HISTORIC AND DESIGN REVIEW COMMISSION

HDRC CASE NO: 2021-113
ADDRESS: 101 PASO HONDO
LEGAL DESCRIPTION: NCB 591 BLK 4 LOT 13
ZONING: RM-4, H
CITY COUNCIL DIST.: 2
DISTRICT: Dignowity Hill Historic District
APPLICANT: George Torres/George Torres Architect
OWNER: Brett Cohen/JRB CAPITAL LLC
TYPE OF WORK: Construction of 4 residential structures
APPLICATION RECEIVED: March 01, 2021
60-DAY REVIEW: Not applicable due to City Council Emergency Orders
CASE MANAGER: Edward Hall

REQUEST:

PROPOSED MATERIALS

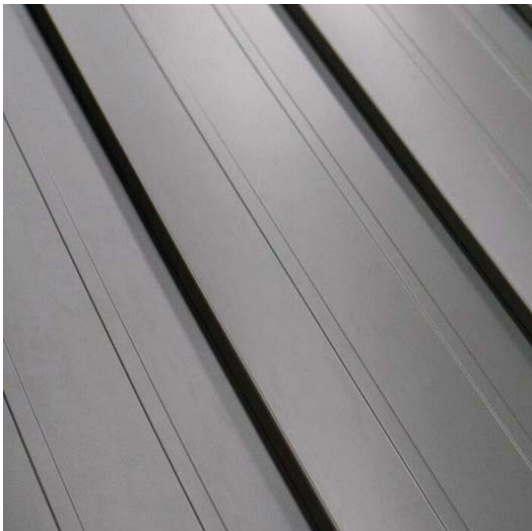
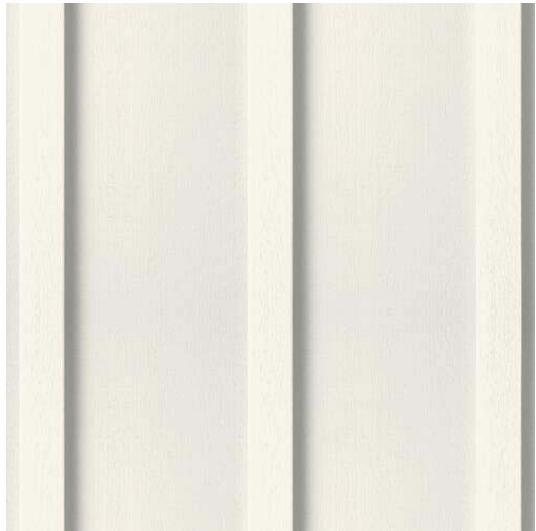
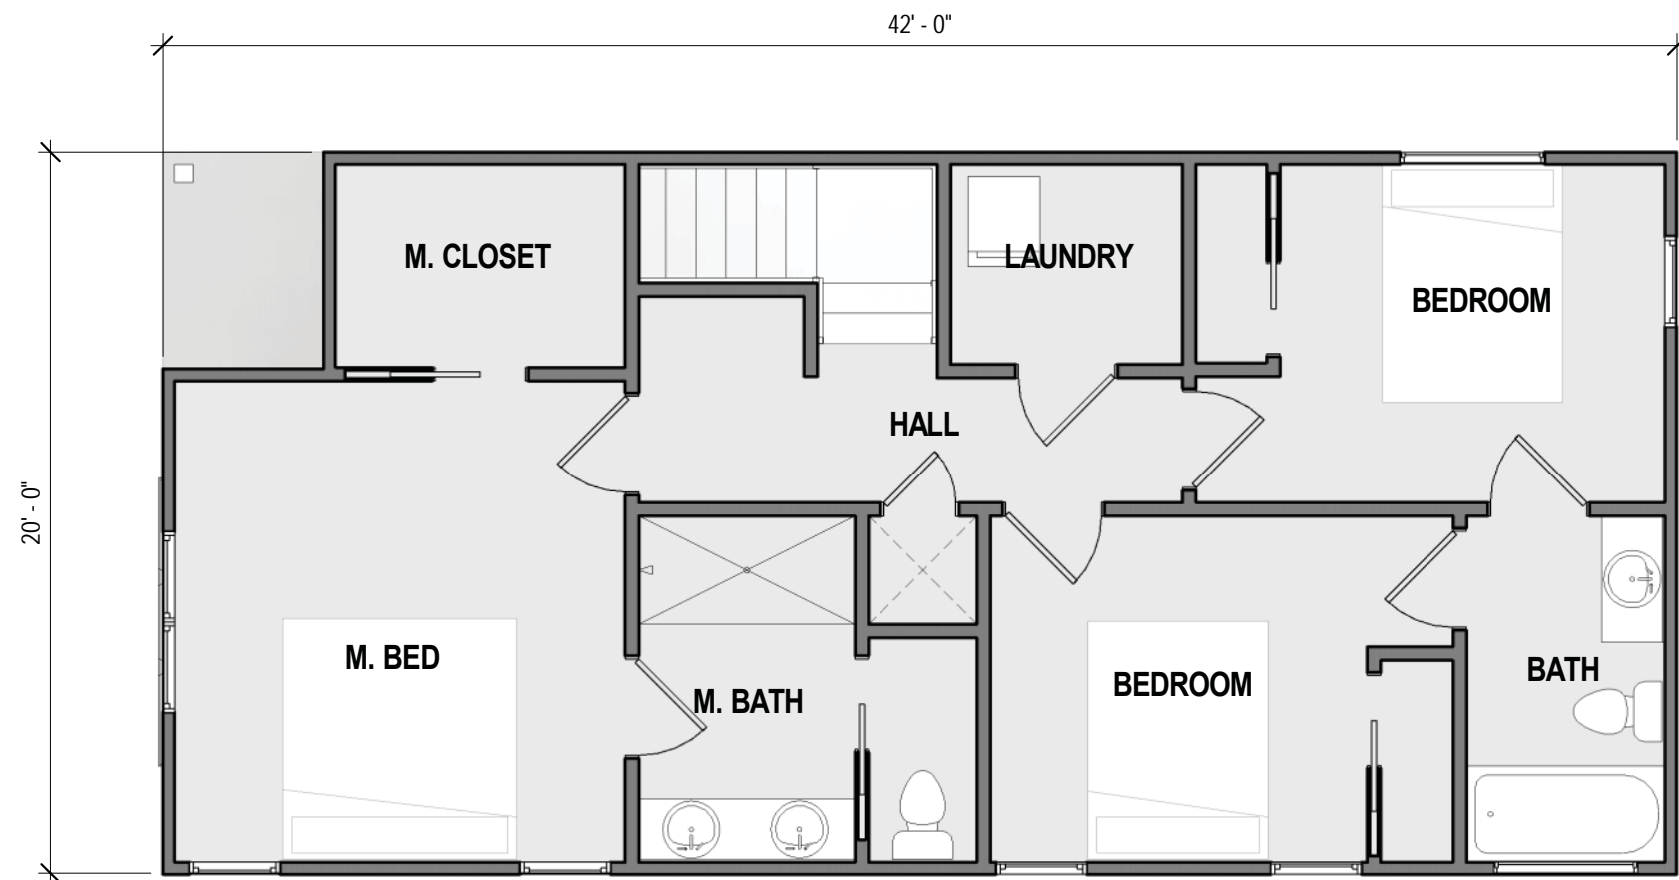
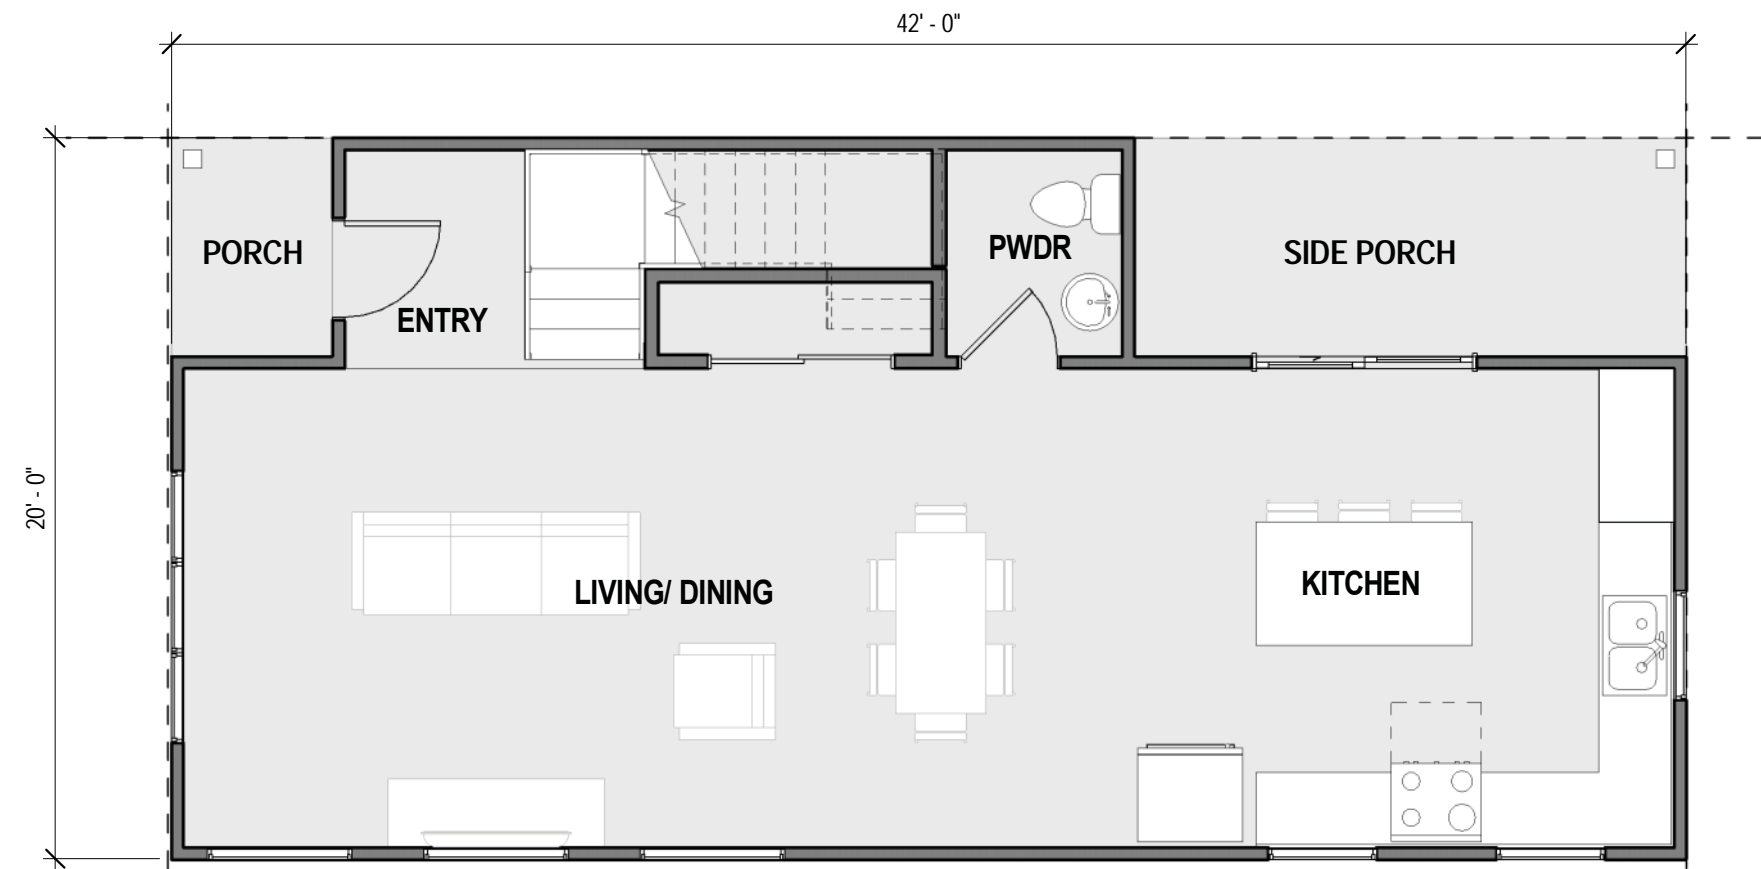
- k. **MATERIALS** – The applicant has noted the installation of standing seam metal roofs, composite siding, steel entry doors, and board and batten siding. Staff finds that all standing seam metal roof should feature seams that are 1 to 2 inches in height, panels that are smooth and 18 to 21 inches in width, a standard galvalume finish, and a crimped ridge seam or low profile ridge cap. Additionally, staff finds that all horizontal siding should feature smooth panels with a four inch exposure and a thickness of $\frac{3}{4}$ of an inch. Regarding board and batten siding, staff finds that all boards should be 12 inches in width with battens that are approximately 1.5 inches in width. Smooth composite siding should be used throughout.

- l. **WINDOW MATERIALS** – The applicant has noted the installation of aluminum clad wood windows. Staff finds that product specifications should be submitted to staff for review and approval that are consistent with staff's standard specifications for windows in new construction.

- vii. That all standing seam metal roof should feature seams that are 1 to 2 inches in height, panels that are smooth and 18 to 21 inches in width, a standard galvalume finish, and a crimped ridge seam or low profile ridge cap. Additionally, staff finds that all horizontal siding should feature smooth panels with a four inch exposure and a thickness of $\frac{3}{4}$ of an inch. Regarding board and batten siding, staff finds that all boards should be 12 inches in width with battens that are approximately 1.5 inches in width. Smooth composite siding should be used throughout.

- viii. That wood or aluminum clad wood windows be used, and that product specifications be submitted to staff for review and approval that are consistent with staff's standard specifications for windows in new construction.
